**DEVIATION REQUEST
AND DECISION FORM**

Project Name : The Commons at Falcon Field Deviation No. 2 Date: 6/2/2023

DEVIATION No. 2 – Access to a Collector Street (Rev. 6/2/2023; Original 1/4/2020): A deviation from the standards of or in Sections **2.2.5.D** and **2.3.2 (Table 2-7)** of the Engineering Criteria Manual (ECM) is requested. Requests for access are reviewed by the ECM Administrator as per ECM Section 2.2.4.B.4. The request is for the following access points to proposed Urban Non-Residential Collector Streets within the Falcon Field development: Two full-movement access points are proposed to the planned Non-Residential Collectors. One access point will be located approximately 385 feet east of the proposed roundabout and will provide access north of the collector. Another access will be located approximately 475 west of the proposed roundabout and will provide access both north and south of the collector. Additionally, two right-in only access points are proposed to be located approximately halfway between the roundabout and the US Highway 24/Woodmen Road intersection.

Deviation Exhibit D1

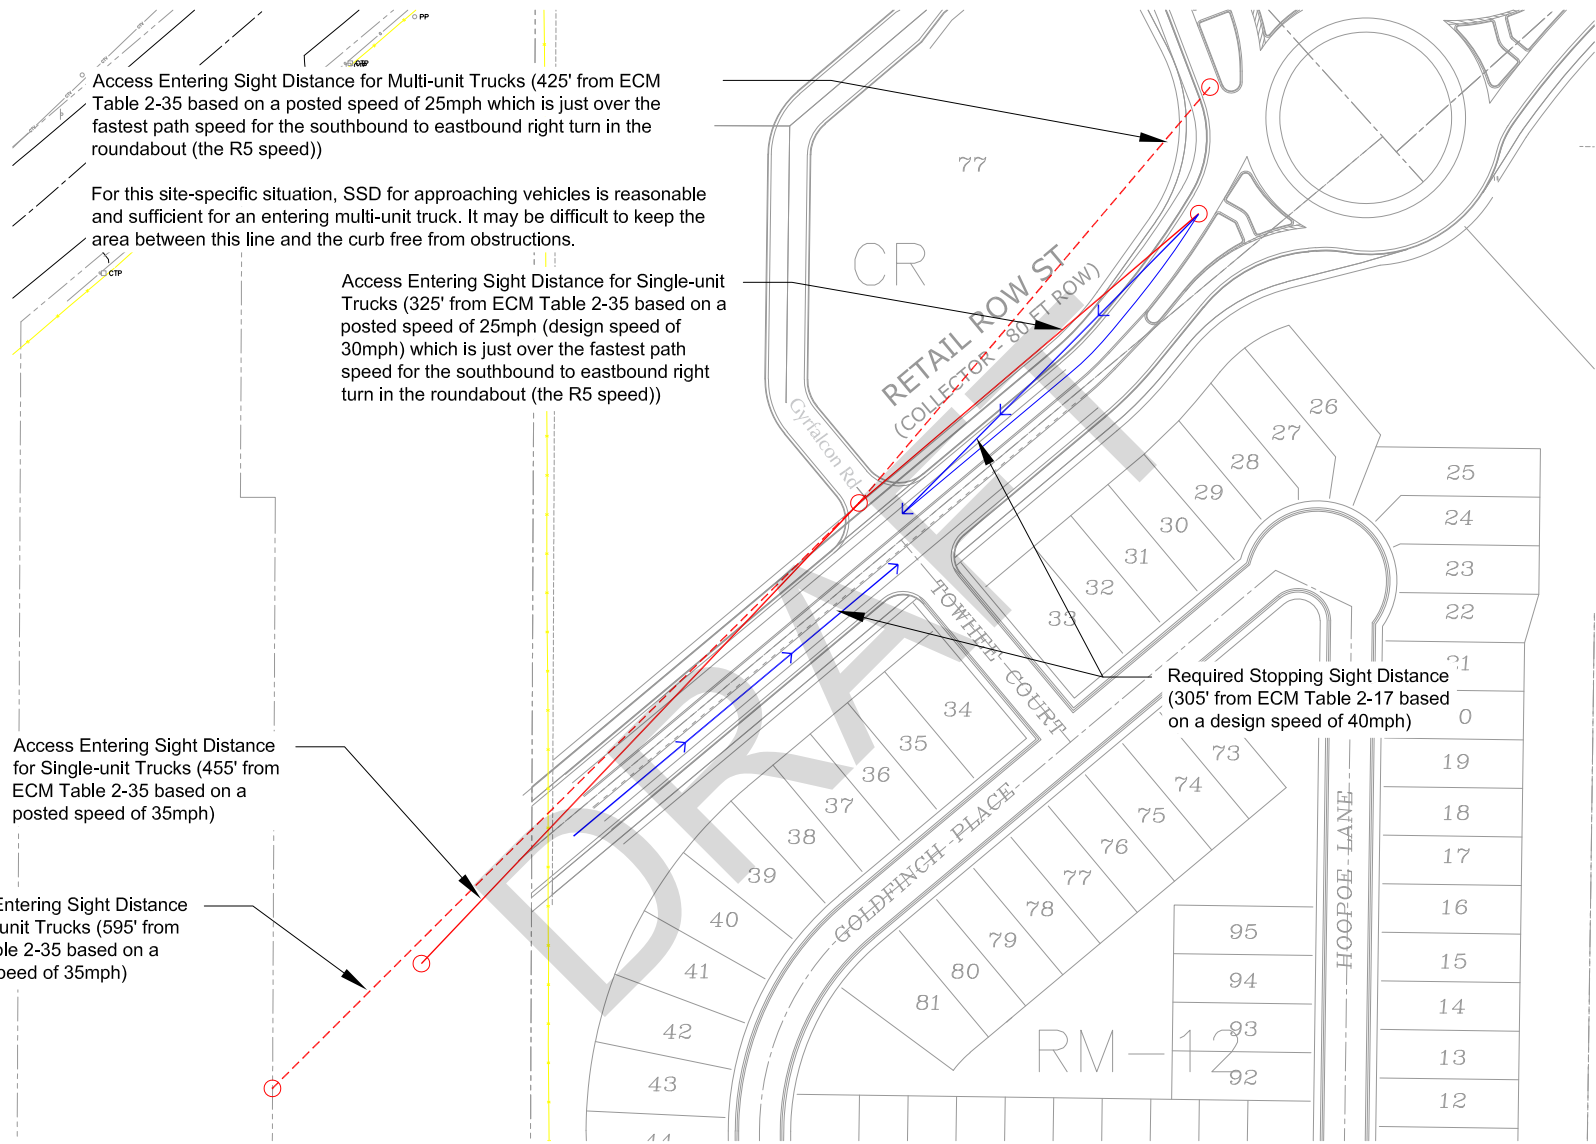
For this site-specific situation, SSD for approaching vehicles is reasonable and sufficient for an entering multi-unit truck. It may be difficult to keep the area between this line and the curb free from obstructions.
